**TOWN OF NEWBURGH  
PLANNING BOARD  
TECHNICAL REVIEW COMMENTS**

**PROJECT NAME:** 273 ROUTE 17K CHANGE OF USE-RESTAURANT  
**PROJECT NO.:** 23-05  
**PROJECT LOCATION:** 273 ROUTE 17K  
SECTION 90, BLOCK 6, LOT 1  
**REVIEW DATE:** 10 NOVEMBER 2023  
**MEETING DATE:** 16 NOVEMBER 2023  
**PROJECT REPRESENTATIVE:** A. HENNESSY ARCHITECTS

# TYPICAL PARKING SPACE DETAIL

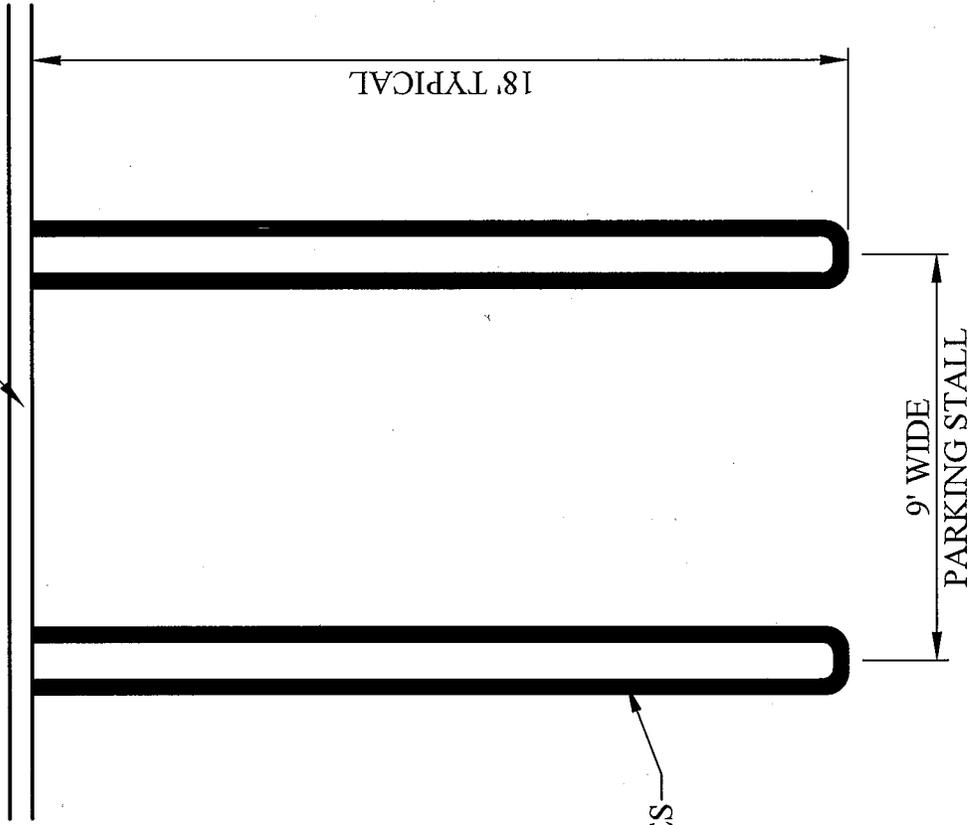
3. Maintenance of the parking lot is required. The plans identify a 1 inch pavement overlay. Parking lot striping should be compliant with Town of Newburgh Standard Detail. Copy Attached.

**1 PROPOSED SITE LAYOUT**  
S1.0 SCALE: 3/16" = 1'-0"

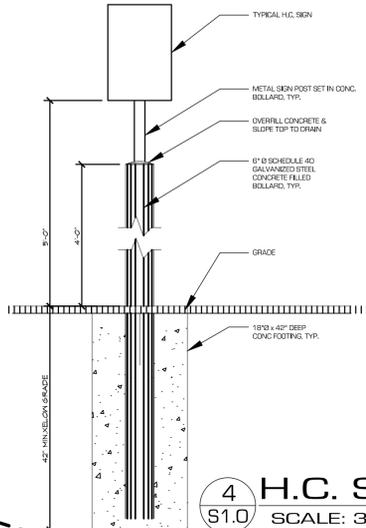
1. Plans should be revised to depict a grease trap for the proposed restaurant.
2. Zoning Variances have been issued for the pre-existing non-conformities on the lot.

4. A neighboring property owner has identified a storm drain which is not depicted on the plans. The applicant's representative are requested to evaluate the existence of the storm drain and depict the same on the plans.

5. Photos documenting the parking area inconsistent with what is depicted on the plans that have been submitted. Existing limits of the asphalt surface on the site should be depicted on the Site Plan.

9. Accessible parking spaces should be identified on the plans with compliant signage.
10. This has been submitted to Orange County Planning, however, based on recent Intermunicipal Agreement with County Planning the change of use does not require County Planning review.
